AXOD/AXODE (AX4S) UPDATE HANDBOOK

INTRODUCTION

This updated version of the AXOD "Update Handbook" will also cover the changes that occurred in the 1991 model year, when electronic controls were adapted to the AXOD transaxle, making it an AXODE, and now called an AX4S transaxle. We have included the changes on the AX4S transaxle up through and including model year 2002.

Figure 2

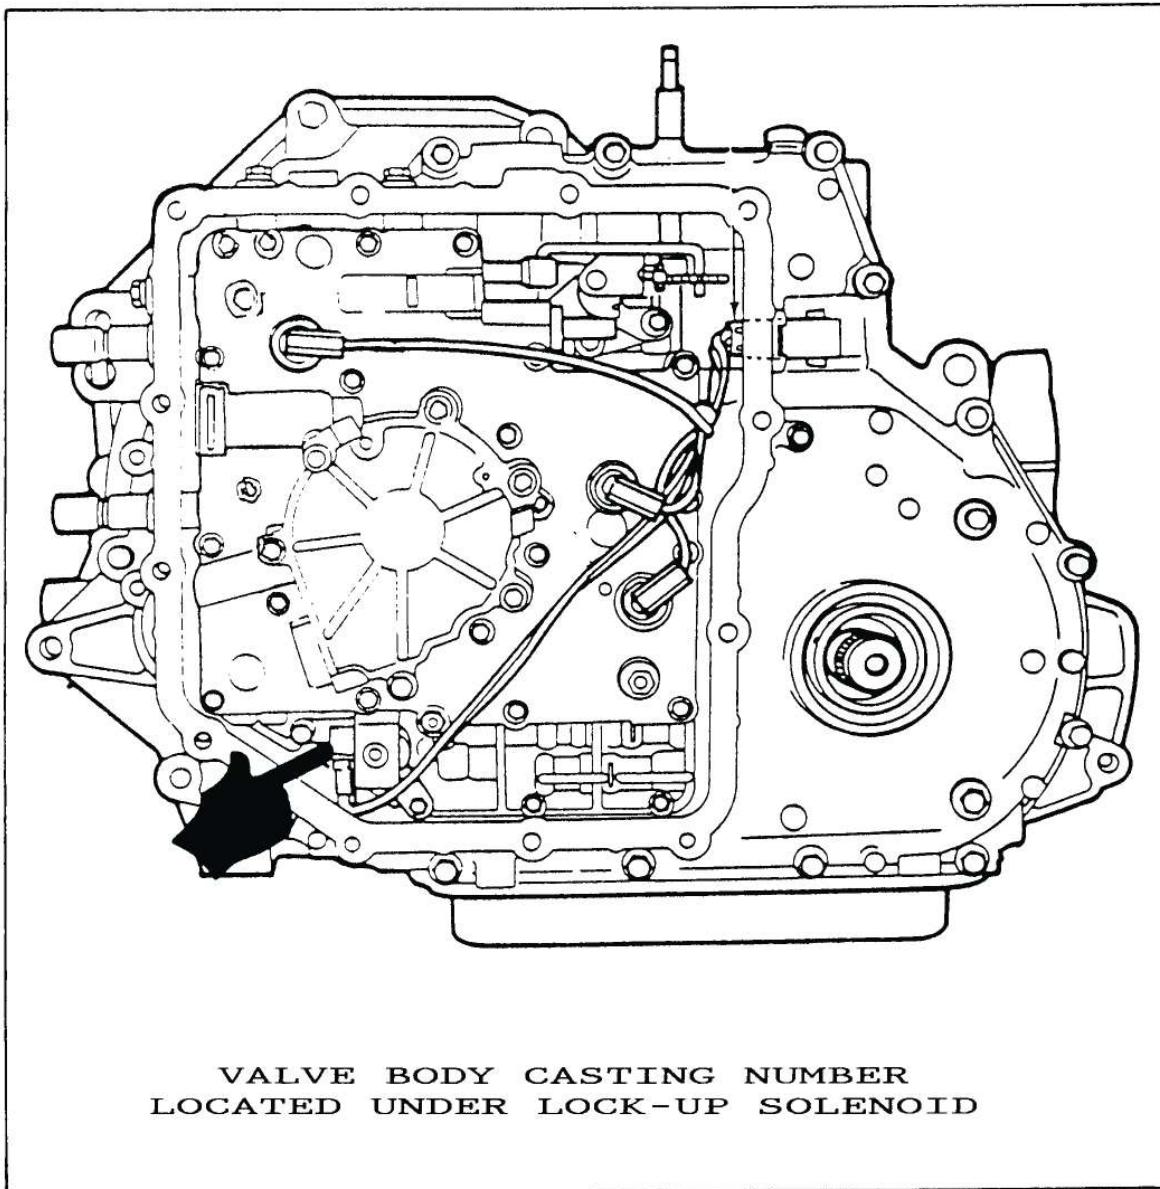
- (4) VALVE BODY CASTING - Must be identified by the casting number located beneath the lock-up solenoid as shown in Figure 2, and can be identified as follows:

Figure 3

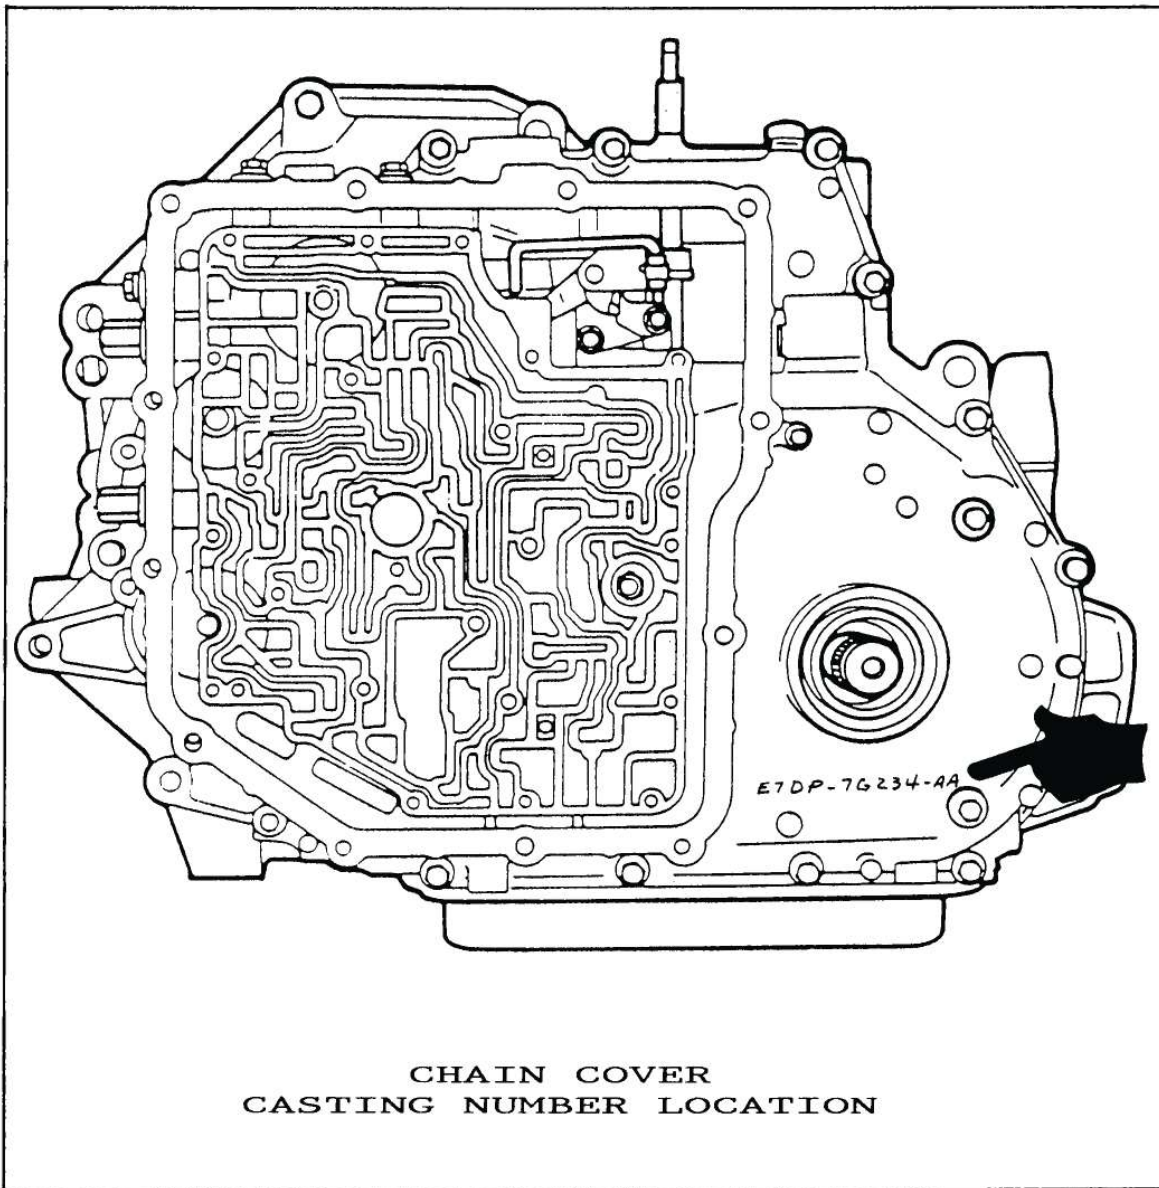
- (7) CHAIN COVER - Must be identified by the casting number located below the axle seal as shown in Figure 3, and can be identified as follows:
- E6SP-7G234-AA = 1986 Hydraulics Only.
 - E7DP-7G234-AA = 1987 Hydraulics Only.
 - E8DP-7G234-AA = 88/90 Hydraulics Only.
- (8) OIL PUMP CHECKBALL LOCATIONS - The 1986 through 1989 oil pumps have 9 checkballs, and locations are shown in Figure 16.
Some 1989 models and all 1990 model oil pumps have 10 checkballs, and locations are shown in Figure 17.

Figure 18

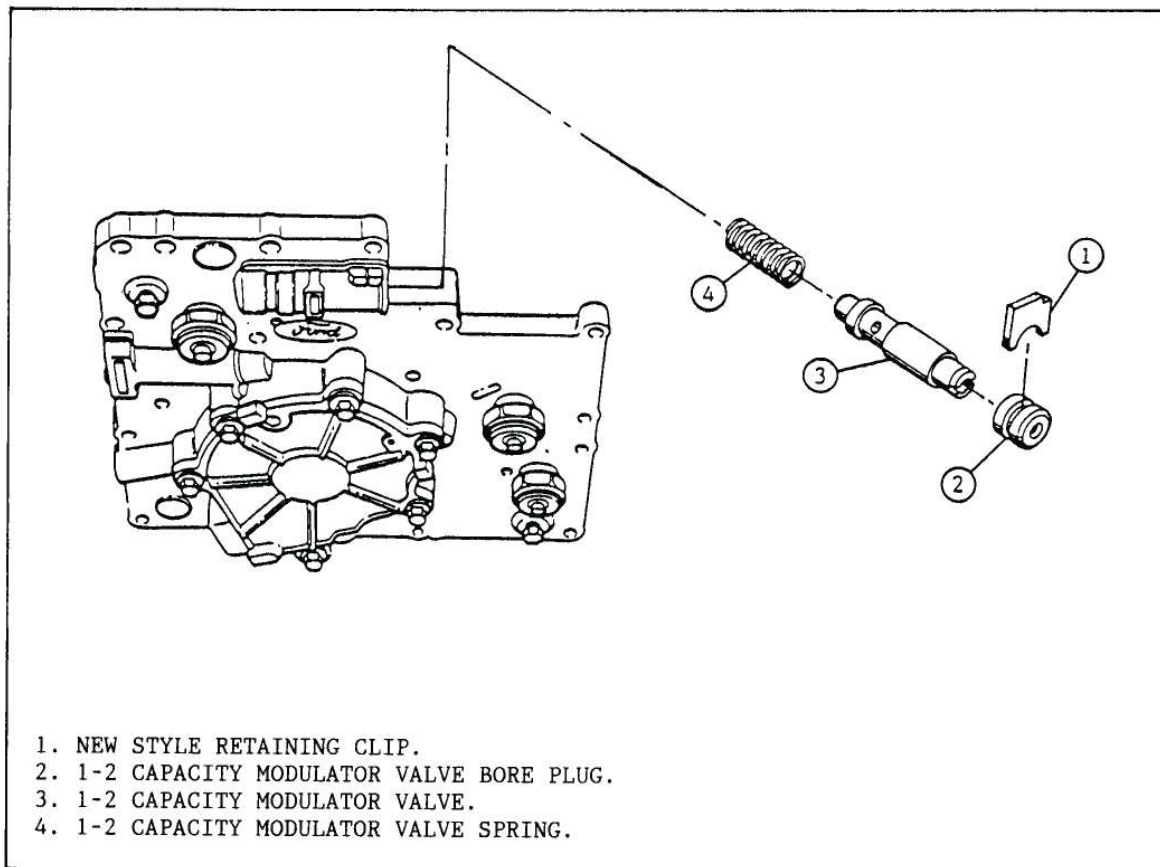
Replace the 1-2 capacity modulator valve spring with the Red spring manufactured by Shift Technology Products (Part #K006). The kit also comes with a new style bore plug retaining clip. Assemble into the oil pump as shown in Figure 18. This modification should be made on all AXOD'S during rebuild.

Figure 19

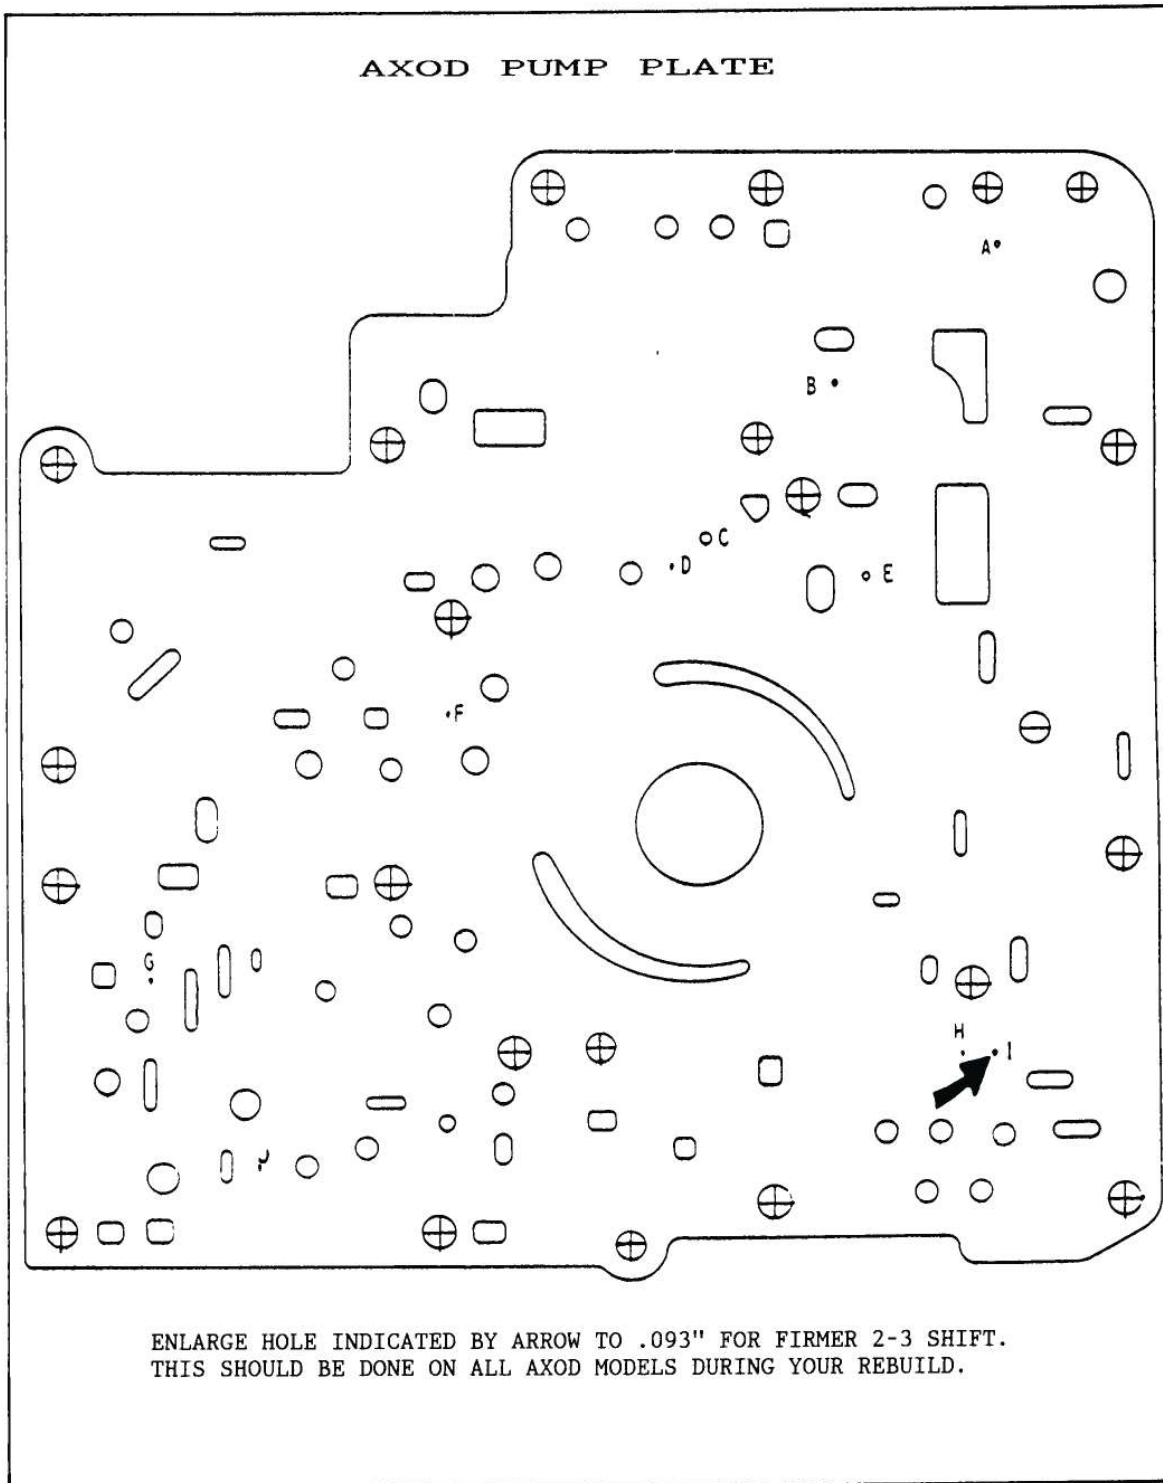
FOR SOFT 2-3 SHIFT:

Drill the direct clutch feed passage in the oil pump spacer plate, hole marked "I", out to .093" as shown in Figure 19.

Figure 27

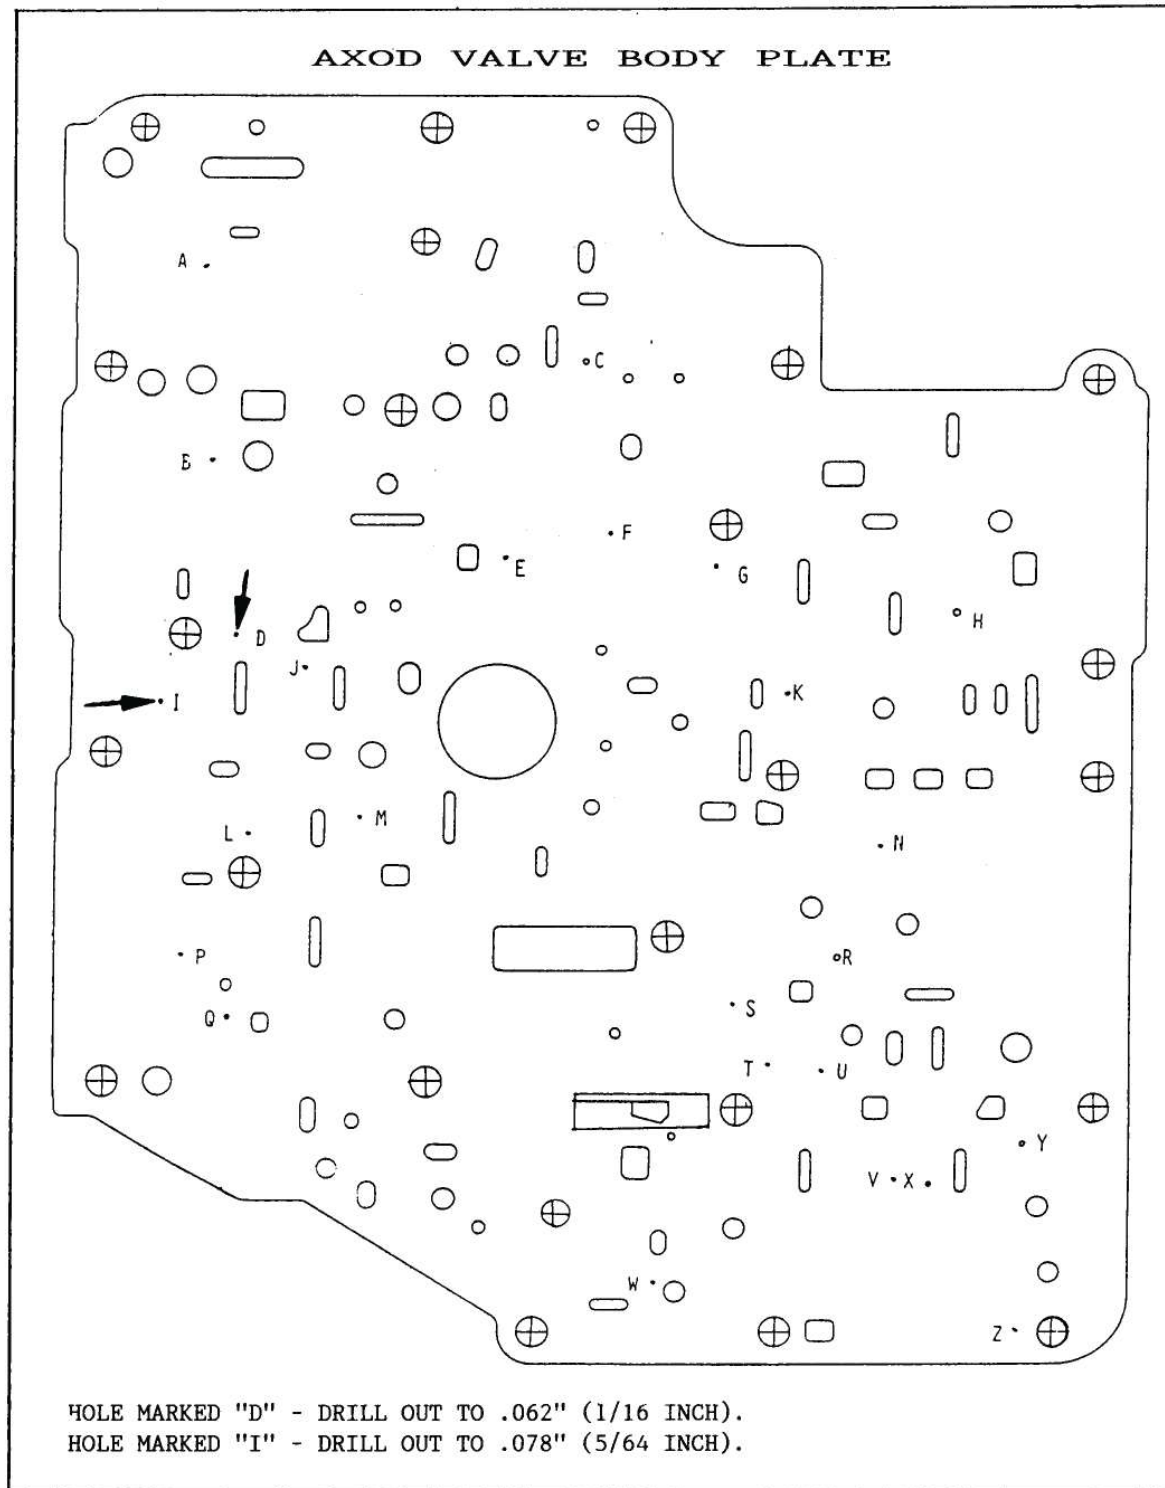
1. Drill the torque converter fill hole in the valve body spacer plate out to .062" (1/16 Inch). This is the hole marked "D" as shown in Figure 27.
Drill the rear lube orifice in the valve body spacer plate out to .078" (5/64 Inch). This is the hole marked "I" as shown in Figure 27.

Figure 31

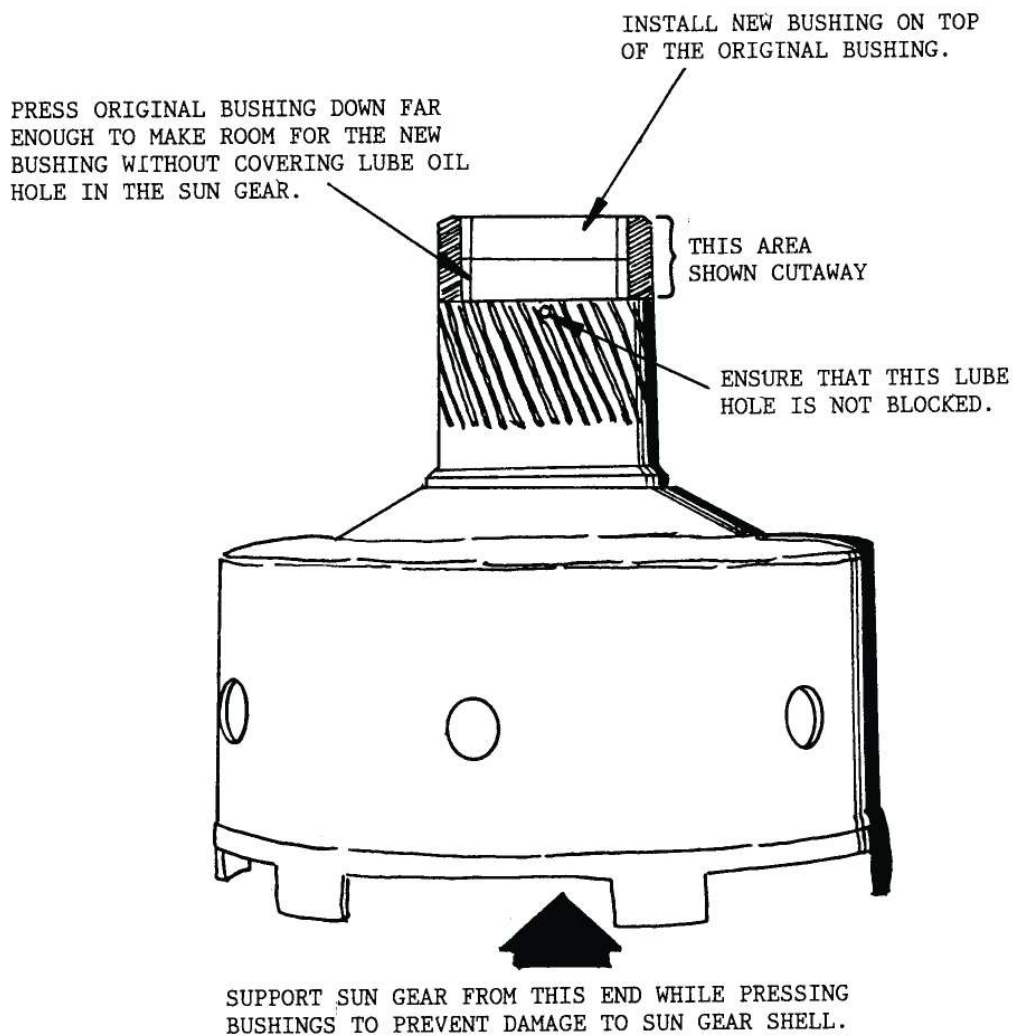
5. Install "Double Bushings" at the rear of sun gear as shown in Figure 31. After both bushings are in place, ensure that lube oil hole in the sun gear is not blocked.

Figure 32

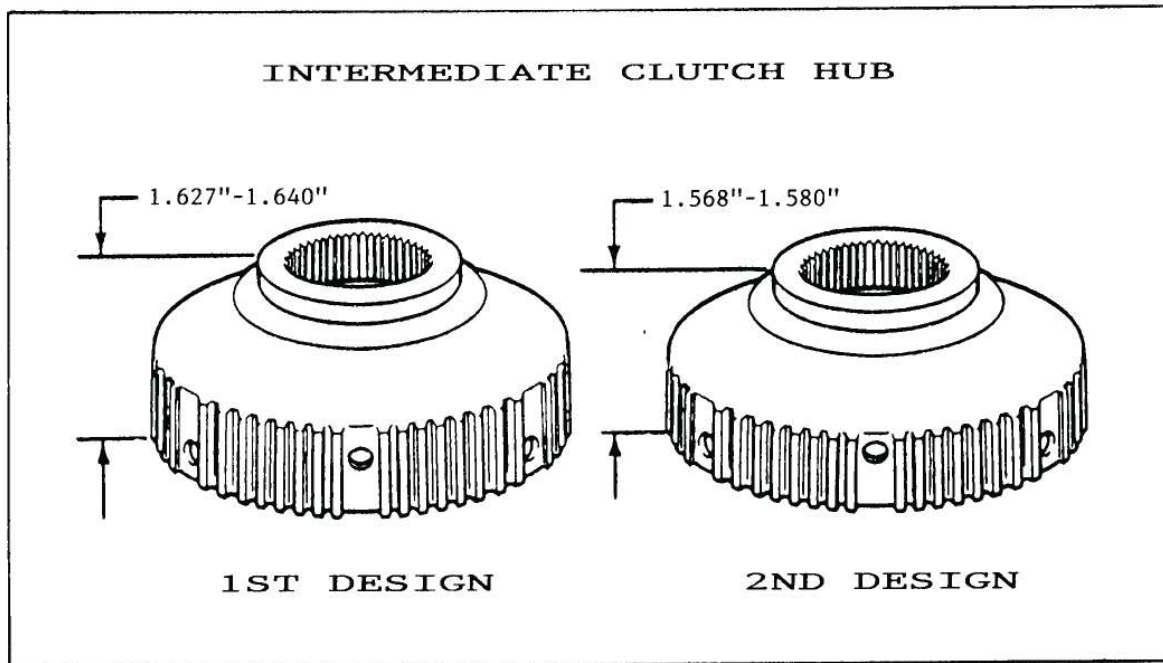
- (2) **INTERMEDIATE CLUTCH HUB** - Overall height was made shorter by approximately .060" with no identifying marks. The hub **MUST** be measured with a dial caliper or depth gage.
The 1st design hub will measure 1.627"-1.640", and the 2nd design hub will measure 1.568"-1.580" as shown in Figure 32.

Figure 40

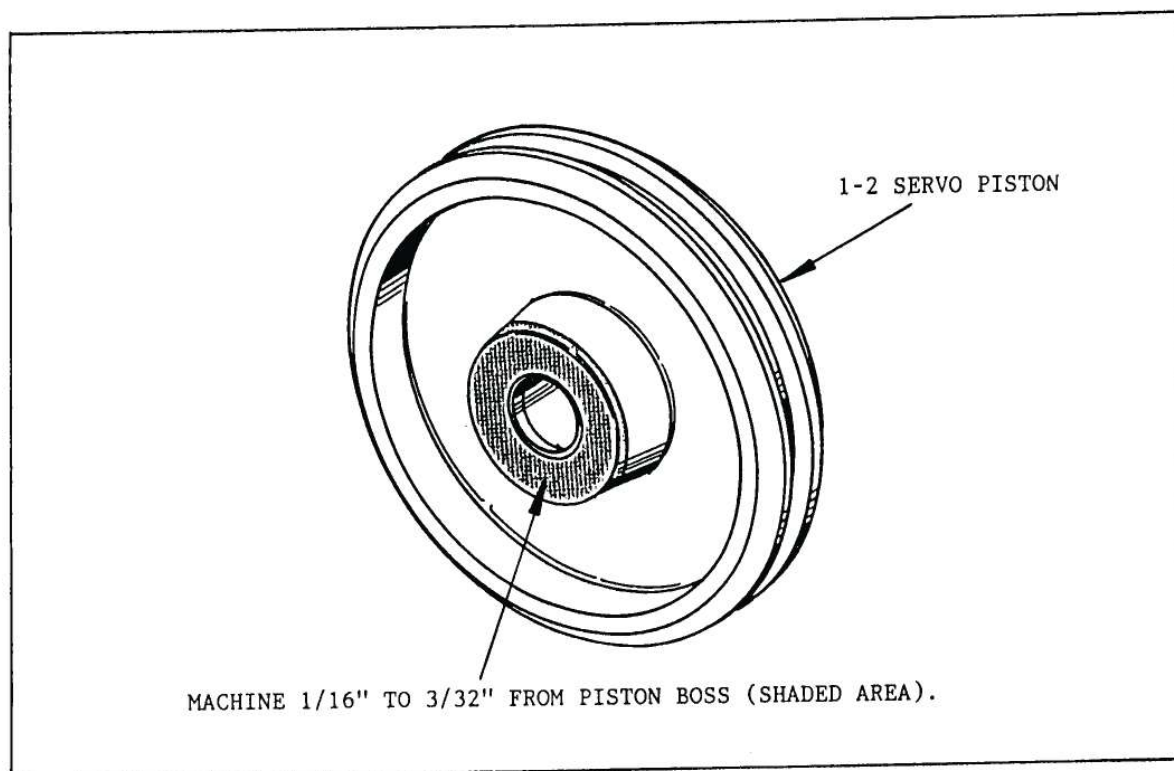
CAUSE: Insufficient travel of the 1-2 piston against the cushion spring.

CORRECTION: Remove $1/16$ " to $3/32$ " from the boss on the inside of the 1-2 servo piston as shown in Figure 40. We have shaded the area to be machined (See Figure 40).
